Staff Report to the Zoning Administrator

Application Number: **05-0486**

Project Description: Proposal to reconstruct a single-family dwelling utilizing the existing foundation and to construct an addition to include a family room and a garage, and to demolish the existing third story and swimming pool.

OPTION 3B - WALLS & DWY

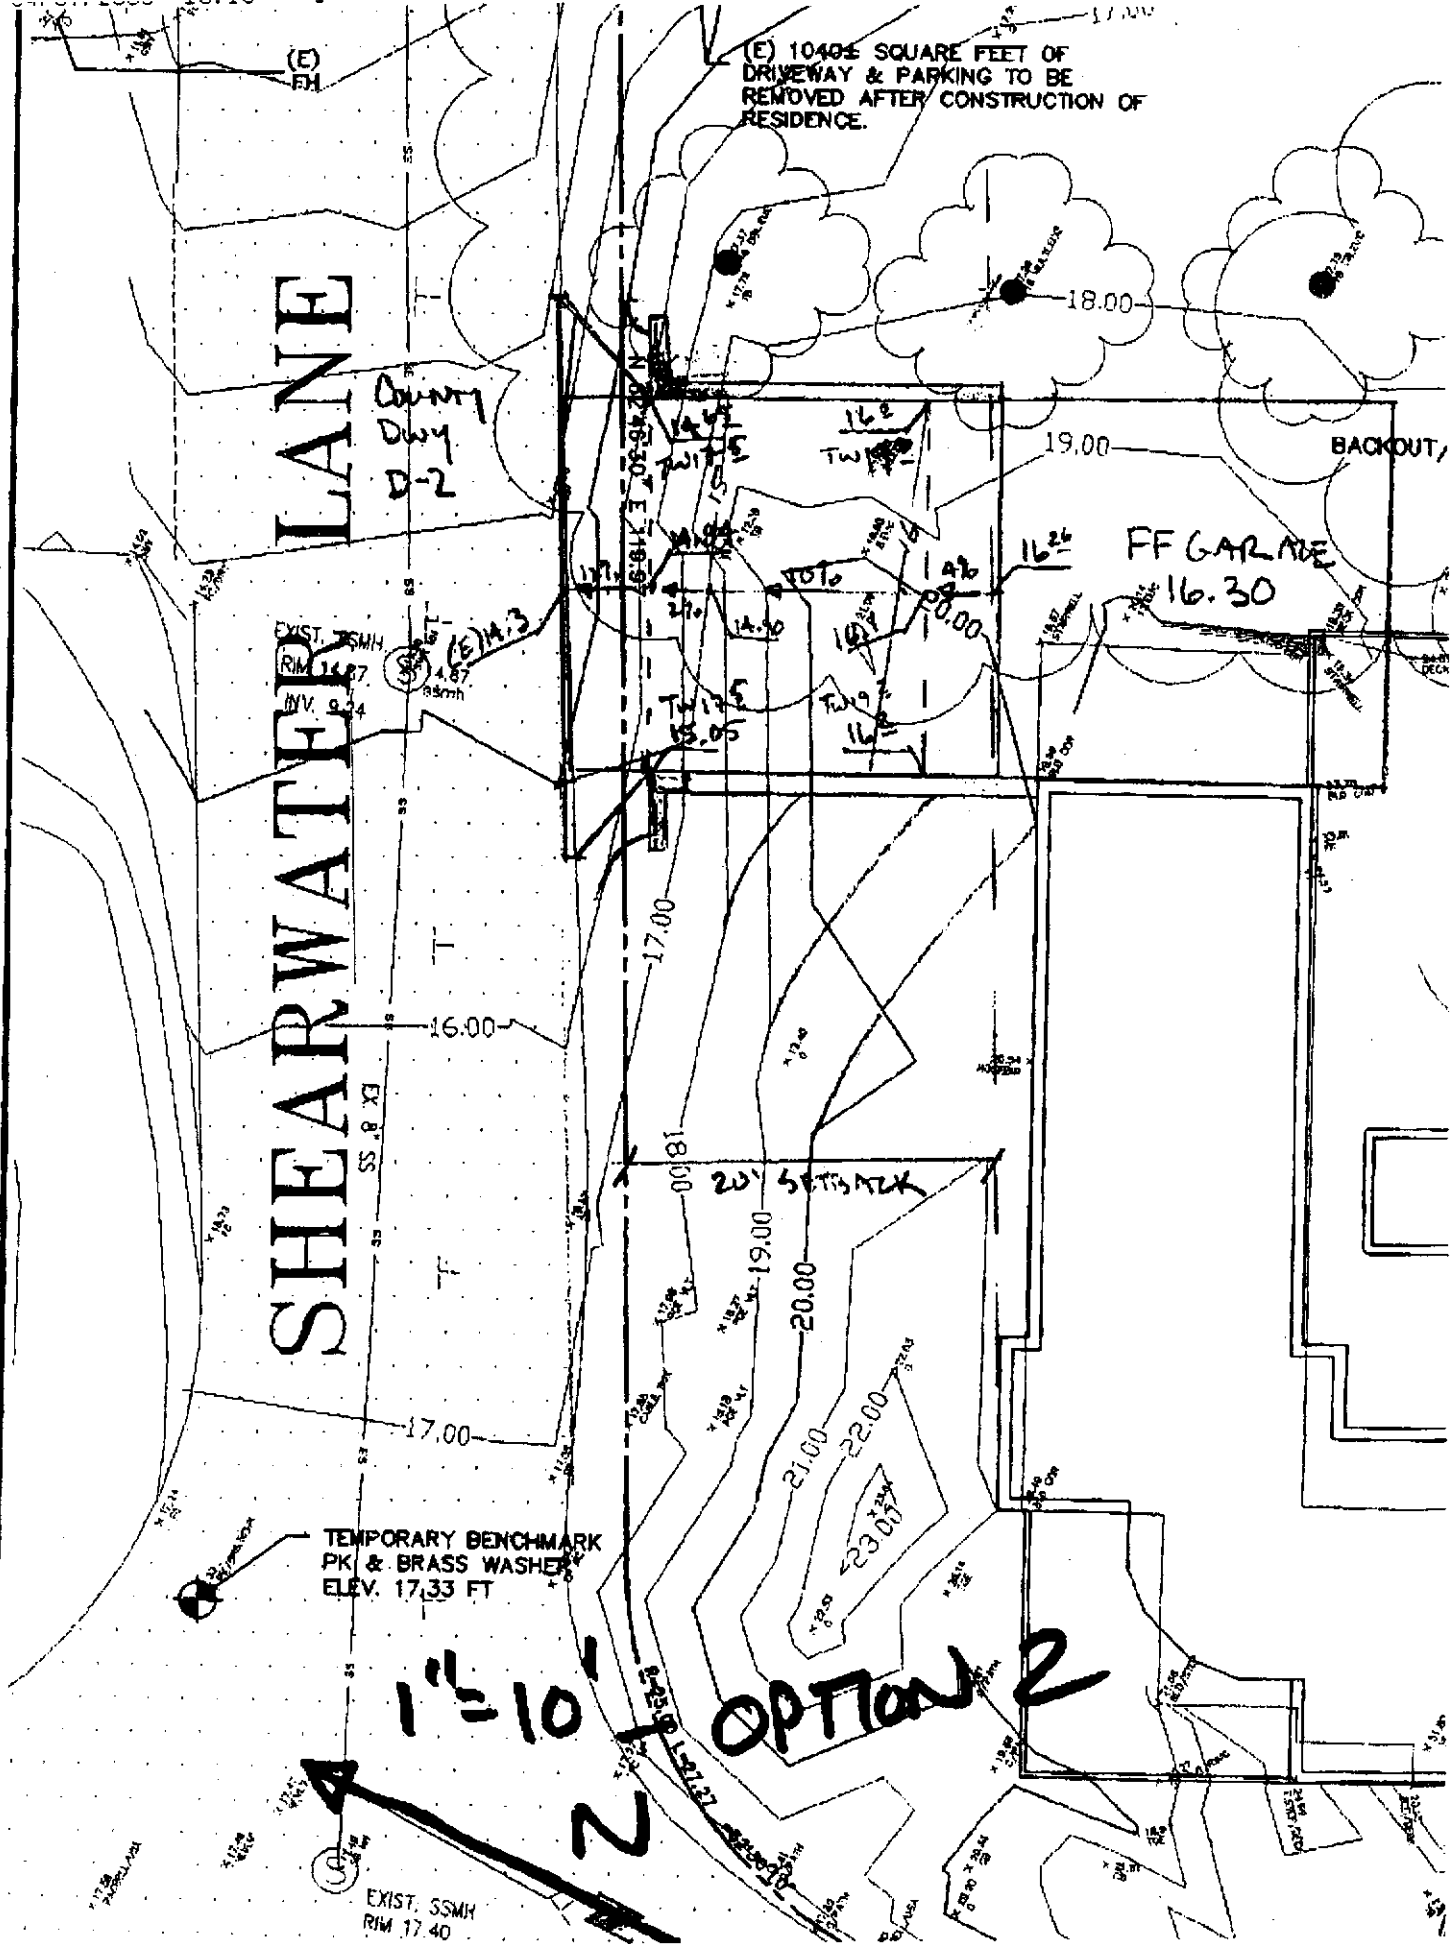
Plans submitted contained three driveway options discussed in our meeting with the architect and owner on 4/6/05. EP still does not approve of "Option 1" which the owner desires. EP has reviewed the other two options and the department can support "Option 2". This option minimizes the grading volume and has the least amount of overall ground disturbance.

SECTION A-A
PERCOLATION TRENCH/LEVEL SPREADER

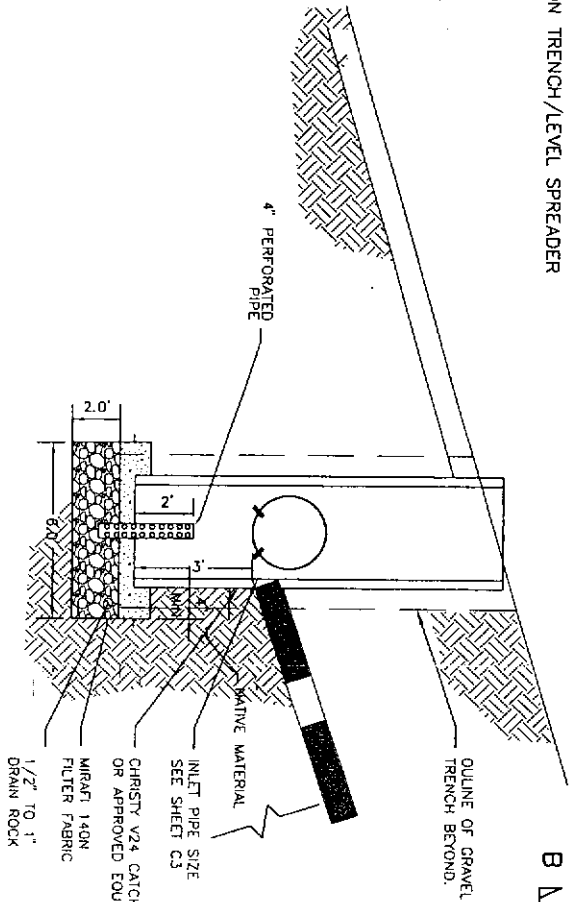
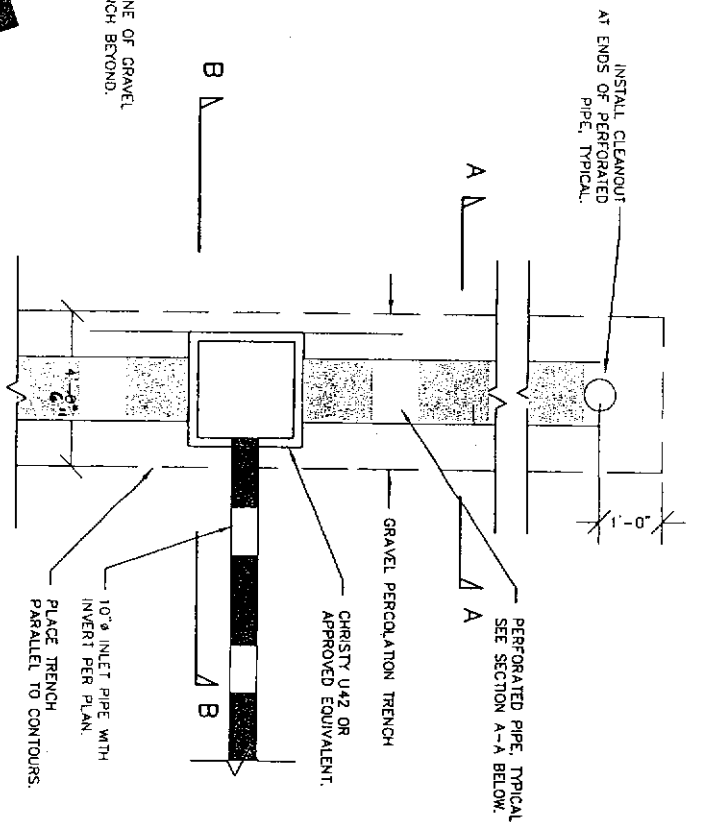
- 2) Add retention details shown on sheet C3.1 in Drainage Analysis & Stormwater Management report to plans.
- 3) Plan View detail on sheet C3.1 in Drainage Analysis & Stormwater Management report shows pipe from driveway perpendicular to retention trench which is opposite to layout depicted in plans. Please match detail to layout shown on sheet C1 of plans.
- 4) Note in plans the amount of new impervious area resulting from development
